1250AC-681, 1275AC-681

Product Bulletin # TDS-166

# **Top Drive Guard Catch Alert**

Figure 1: Possible catch points on the top drive guard

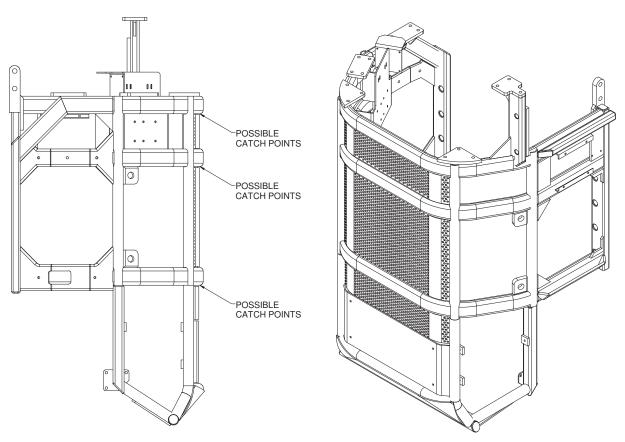
Some top drive guards contain perforated plate on the front of the guard that is recessed 1.25" from the face of frame creating a possible catch point. Should drill pipe or other tubulars make contact with the front of the top drive guard while the top drive is descending, the pipe can become entrapped on the structure of the guard.

Figure 2: Modified guard included with the kit

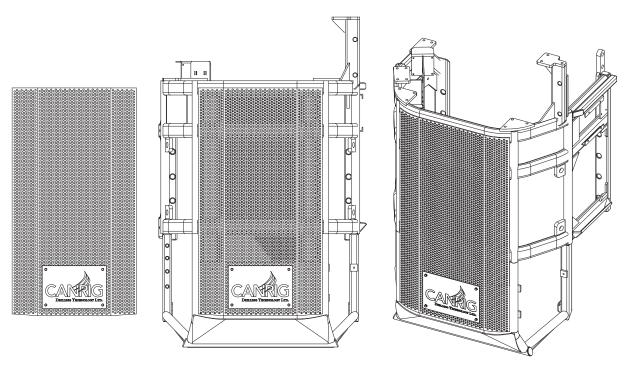
Should preventative methods fail, a guard modification kit is available. This kit eliminates the possible catch points by providing one continuous surface free from any recesses. To install the kit, the existing perforated plate will need to be cut out and removed in the locations described on Figure 3 on page 3, and a new replacement plate will have to be weld in. Contact RIGLINE 24/7<sup>TM</sup> Support to purchase the components under kit AY23335.

Figure 3: Remove existing plates

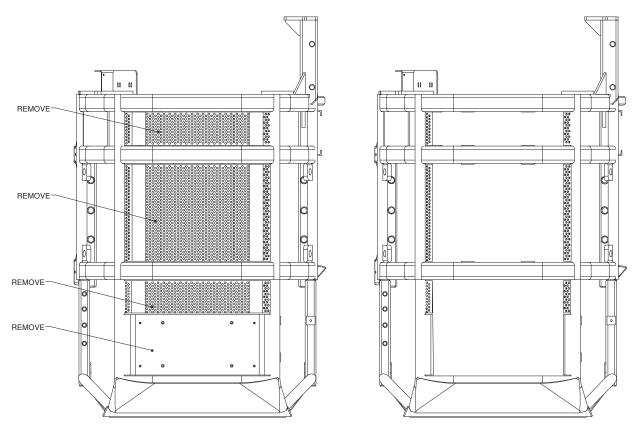
1. Cut out existing perforated plate and nameplate mount as shown on Figure 3.

Figure 4: Top Drive Guard Cover Kit

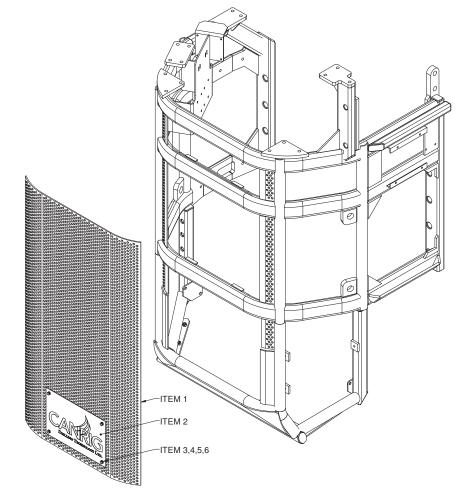
2. Place perforated guard cover (item 1 on Table 1) onto surface of existing cage. Make sure bottom of perforated plate (determined by the nameplate mounting hole location) is flush with the pipe at the bottom of the cage to ensure proper fit. See Figure 4.

Figure 5: Welding instructions

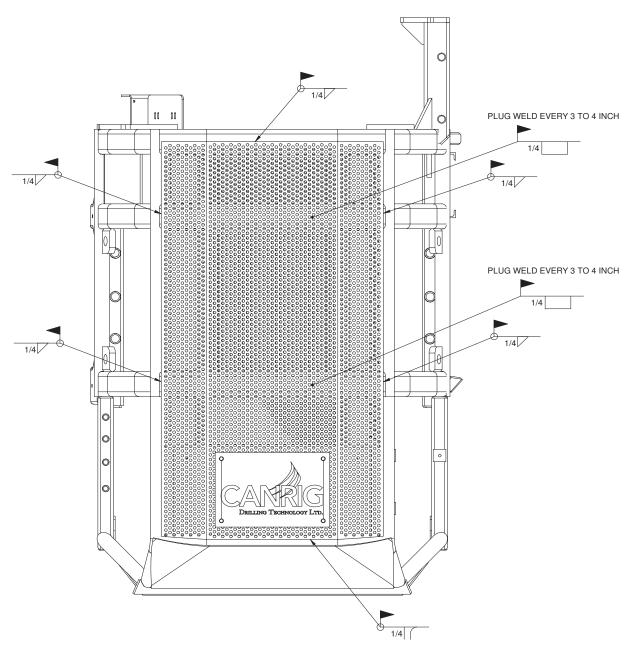
3. Weld Item 1 to existing tubing of cage frame as shown on Figure 5 using E7018 welding rod or equivalent per the welding method used.

Figure 6: New perforated plate after installation

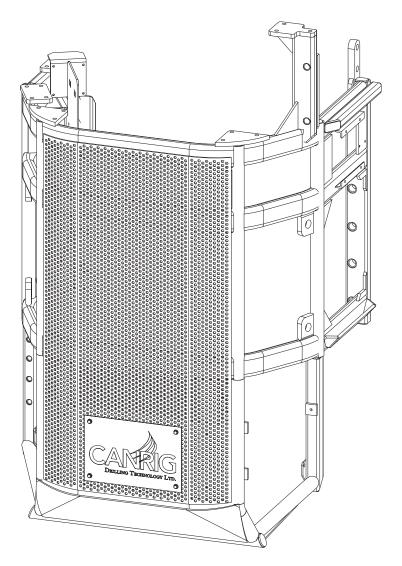
- 4. All bare steel will need to be painted to minimize the possibility of rusting.
- 5. Locate nameplate (item 2) with the tapped holes provided. Apply Loctite 242 or equivalent to 3/8" bolts (item 3) and use to secure nameplate in conjunction with lock washers (item 4). Torque 3/8" bolts to 40 ft-lbs per Canrig Engineering Specification ENG 725.
- 6. Safety wire 3/8" bolts using 1/16" diameter wire rope (item 5) and 1/16" oval sleeve (item 6) to prevent loosening of bolt and retaining bolt head in case of failure per Canrig Engineering Specification ENG 701.
